UNITED STATES PATENT AND TRADEMARK OFFICE

Office Action Summary

10/815,440

DETAILED ACTION

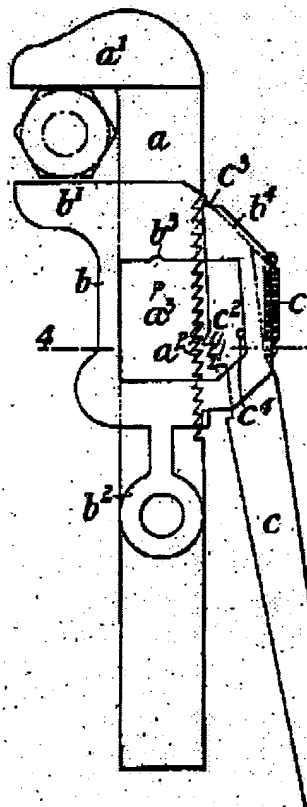
6. Claims 1, 2, 9 and 10 are rejected under 35 U.S.C. 102(b) as being anticipated by Stocker (588,365).

Stocker discloses all of the limitations of claims 1 and 9, i.e., an adjustable type pliers tool comprising a first tool member pivotally attached to a second tool member, each said tool member having a handle portion (c, a), and a head portion (b, a¹) comprising a jaw (b¹, a¹); said first tool member being formed having a slot, said second tool member being formed having pin (a³) attached thereto for interaction with the slot of said first tool member, the head portion of said first tool member having a distinct outer shape when said plier tool is viewed from a side view thereof, the distinct outer shape comprising a first section, a second section and a third section with the second section positioned between said first and third sections, and, the first section having a substantially convex curved outer shape, the second section having a substantially concave curved outer shape, and, the third section having a substantially convex curved outer shape so as to provide said adjustable plier tool with excellent jaw engagement accessibility, wherein the slot extends generally perpendicular to the work engaging surface.

Regarding claims 2 and 10, Stocker meets the limitations, e.g., second jaw having the distinct outer shape (third section just above b²).

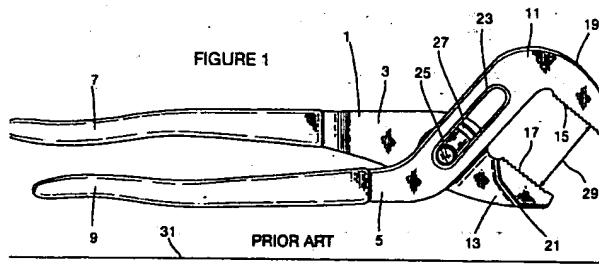
8. Claims 3, 4, 6-8, 11-14 are rejected under 35 U.S.C. 103(a) as being unpatentable over Stocker.

Stocker as applied above meets all the limitations of the above claims, except for disclosing an overall tool length being between 5 and 6 times the maximum spacing between the jaws. Stocker appears to disclose a ratio of about 6.5, i.e., 103 mm overall length and 16mm maximum spacing. However, choosing the overall length to be shorter for ease of storage and/or carrying, e.g., of about 90 mm would be well within the knowledge of one of ordinary skill in the art.

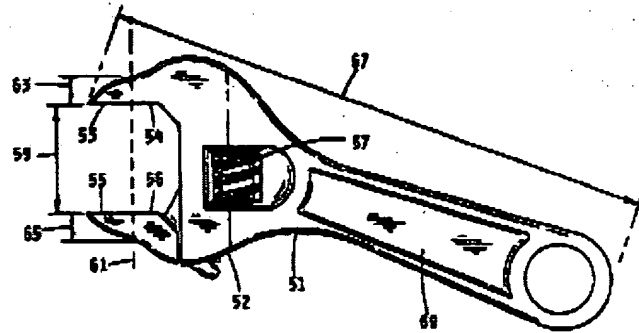
9. Claims 1-20 are rejected under 35 U.S.C. 103(a) as being unpatentable over Applicants Admitted Prior Art (AAPA) in view of either Macor (6,484,610).

AAPA, e.g., Fig. 1 meets all of the limitations of the above claims, except for the unique outer shape and the dimensions of the pliers, i.e., overall length ratio with respect to the maximum spacing.

Macor teaches accessible adjustable wrench having the distinct outer shape and specific dimension ratios, e.g., shorter handle lever. It would have been obvious to one of ordinary skill in the art, at the time the invention was made, to modify the invention of AAPA with the jaw

shapes and overall dimensions as taught by Macor to adapt the tool for engaging and accessing fasteners located in limited access environment.

With regards to the overall dimension relative to the maximum spacing of the jaws, Macor teaches a ratio of less than 7, including embodiments (e.g. less than 6) meeting the open ended range of claims 3, 7, 11, 13, 17 and 19, with regards

to claims 4, 6, 8, 12, and 18, further modifying the range for a particular application, e.g., between 5 and 6, would be well within the knowledge of one of ordinary skill in the art and since it has been held that where the general conditions of a claim are disclosed in the prior art, discovering the optimum or workable ranges involves only routine skill in the art. *In re Aller*, 105 USPQ 233.
